VALUE ENGINEERING CHANGE PROPOSAL
MISSOURI DEPARTMENT OF TRANSPORTATION

Contract ID 080919-701 **Job No.** J7I0599

SUBJECT: Contract 080919-701
Job No. J7I0599
Route 44, Lawrence County
Value Engineering Proposal

BRIDGE: RTE. 39 OVER I-44

Revised
Layout

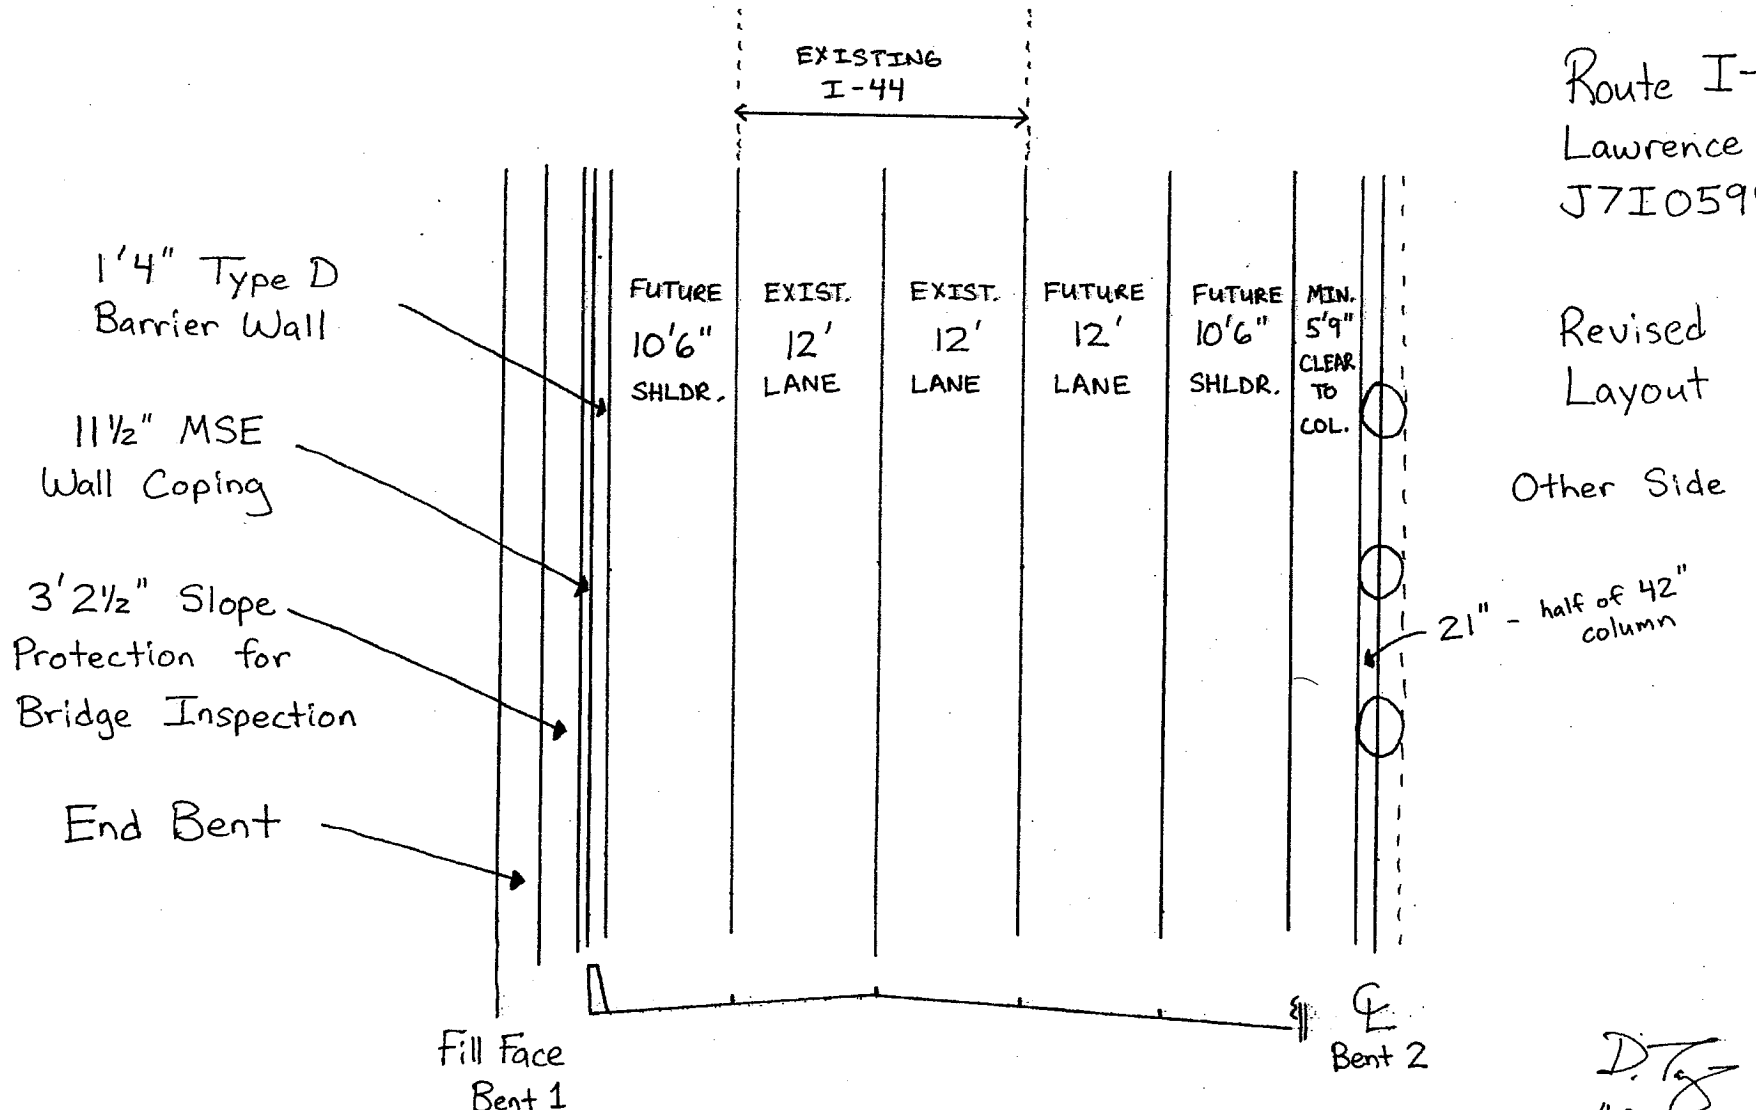
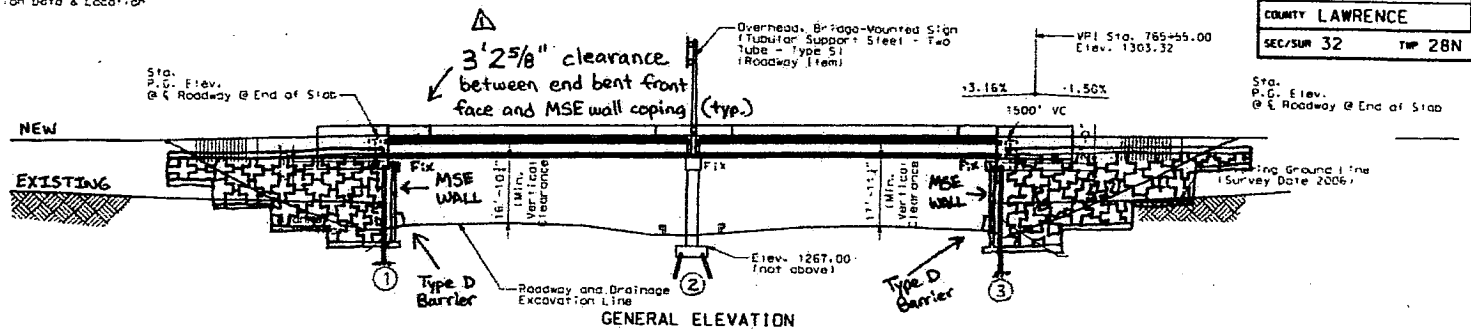
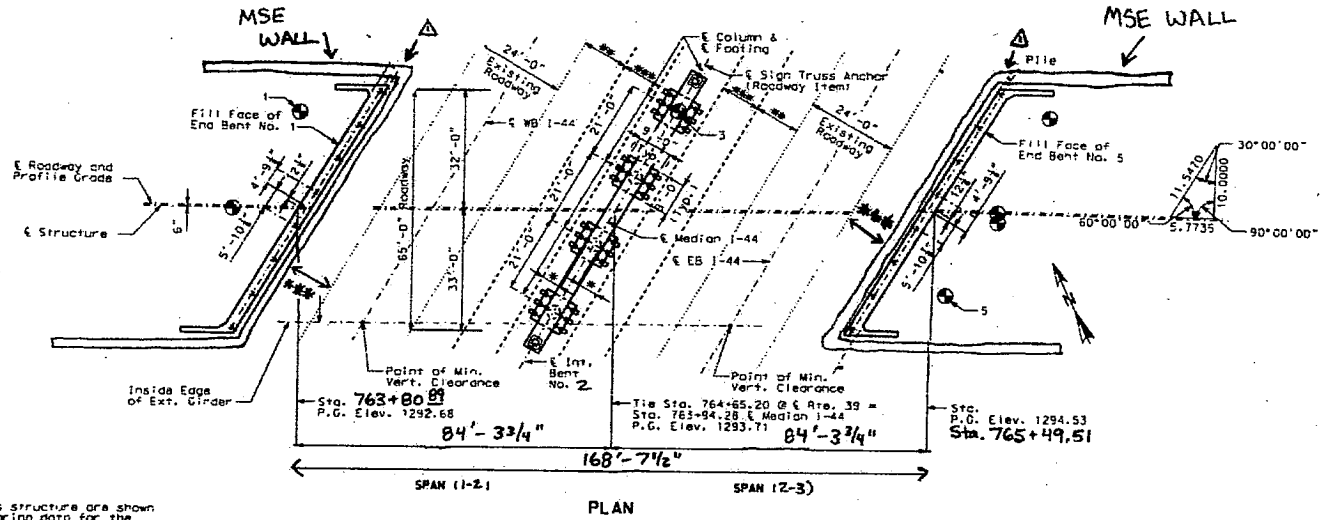
1. **Description of existing requirements and proposed change(s). Advantages/Disadvantages**
   Bridge No. A7574 is currently designed as a 4 span, 5 bent structure of Route 39 over Route I-44. This proposal is to eliminate spans 1-2 and 4-5 on the structure and replace Bents 2 and 4 with End Bents on piling behind MSE walls. The MSE walls will tie into the Route 39 fill slopes, minimizing changes to the excavation quantities. This will result in reduction is many bridge quantities and some roadway quantities. The advantages of this proposal are total cost savings, smaller bridge area for maintenance in the future, and less impact to Route I-44 during construction. The disadvantages are the time required for engineering design and review and the cost of the design.

Comments: The attached "Revised Layout" for I-44 was approved by Dan Smith, MoDOT, on 11/04/08. The revised bridge plans are currently being designed. This proposal is being submitted now to expedite approval of final design. The attached savings schedule is preliminary as final qty's are not yet determined. Final savings will be verified before acceptance. I recommend approval provided final savings is near that proposed here. All design costs are the responsibility of the contractor.

* PROPOSAL REJECTED – UNABLE TO ACHIEVE ACCEPTABLE DETAIL DESIGN, 3-3-09 DGB
